# United States Patent and Trademark Office

APPLICATION NO.	FILING DATE	FIRST NAMED INVENTOR	ATTORNEY DOCKET NO.	CONFIRMATION NO.	
10/773,215 02/09/2004		Chin-Pei Lin	P05025	6745	
40401	40401 7590 03/09/2006			EXAMINER	
HERSHKOVITZ & ASSOCIATES 1725 I STREET NW, SUITE 300			GARCIA, ERNESTO		
WASHINGTON, DC 20006			ART UNIT	PAPER NUMBER	
			3679	·

#### **DETAILED ACTION**

Desard, 6,368,013

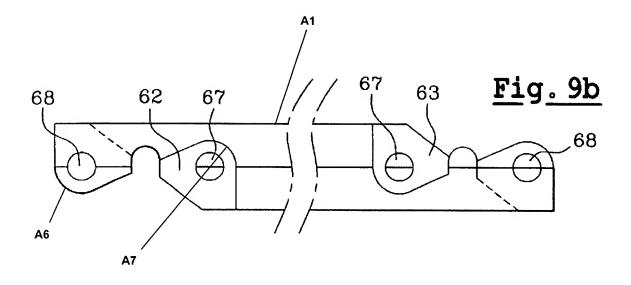
Regarding claim 1, Desard discloses, in Figure 3 and 9b, a do-it-yourself assembly construction piece comprising a body A1 (see marked-up attachment) with multiple ends and a thickness. At least one connecting portion 60,61 extends respectively from the ends of the body A1. The at least one connecting portion 60,61 has a through hole 68, a convex distal edge A6, and a thickness half the thickness of the body A1. The body A1 has a concave face A7 formed concentric with the through hole 68 in each connecting portion 60,61.

Regarding 3, the body **A1** is a bent longitudinal body **A1** with two of the ends, an inner side and an outer side. The connecting portion **60,61** of each of the ends is formed on the outer side (see Figure 3).

Regarding claim 13, the assembly construction piece has the body being a long body **A1** with two of the ends bent in different directions and the ends are parallel to each other.

Regarding claim 4, the body A1 is a bent longitudinal body A1 with two of the ends, an inner side, and an outer side. However, the connecting portion 60,61 of each of the end is not on the inner side, but the outer side. Applicant is reminded that a mere reversal of the essential working parts of a device involves only routine skill in the art; therefore, it would have been obvious to one having ordinary skill in the art at the time the invention was made to place the connecting portions on either the inner side or the outer side as either orientation will allow a connection. *In re Einstein*, 8 USPQ 167.
